### RE: AIR CONDITIONING UNIT - No 2 BEAUCHAMP PLACE

# RBKC District Plan Observations CONSERVATION AND DESIGN

Appl. No. 98/0719/JU C.A. N

Re: Town and Country Planning Act 1990 2-5, 8 and 10 Beauchamp Place, SW3

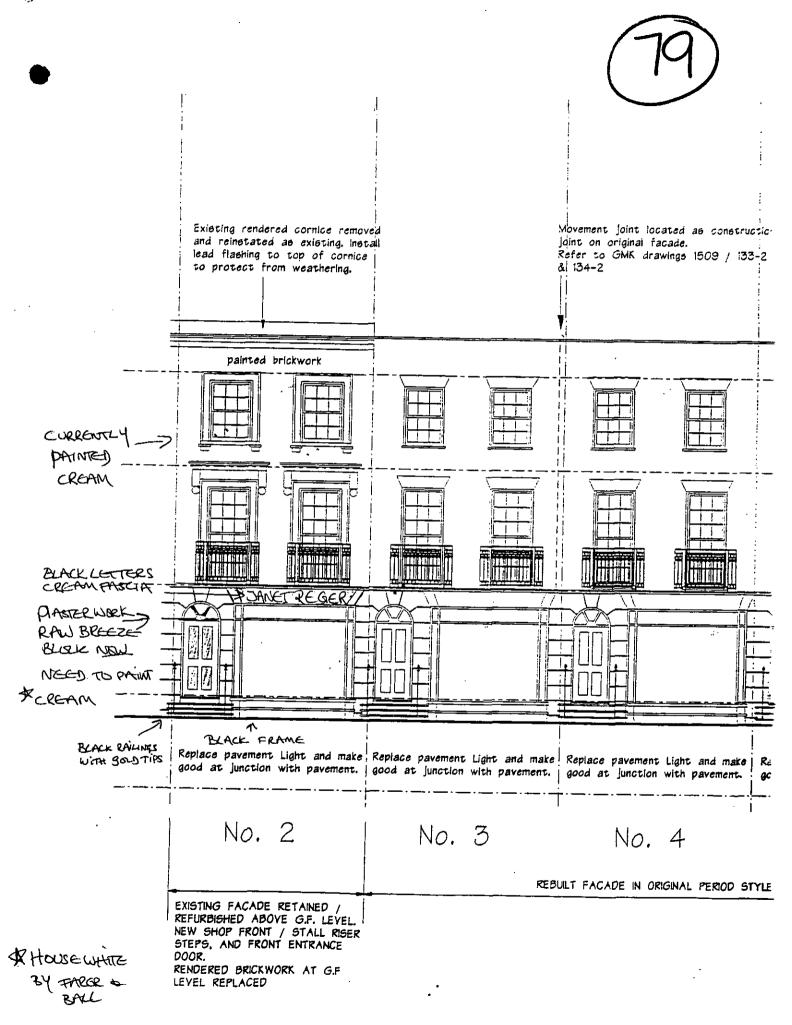
You spoke with my collegue Samantha Jackson on Tuesday May 16th at approximately 5.30 pm. with reference to the exterior paintwork.

As the building stands now it is painted cream from the first floor upwards. The retail level exterior is as yet unfinished but shows large breeze blocks which will be plastered over. For the last 25 years the lower level (ie, retail) of this unit has been plaster finish and painted. The upper level are no longer part of my premises and therefore do not concern me, however I am most concerned how I am to retain a brick work finish where there is none to start with.

Please respond urgently as the exterior works will be carried out this week. With this fax please find enclosed a copy of the front elavation - we would like to paint the fascia and plasterwork in cream, the window frame black and the rails in black with gold tips.
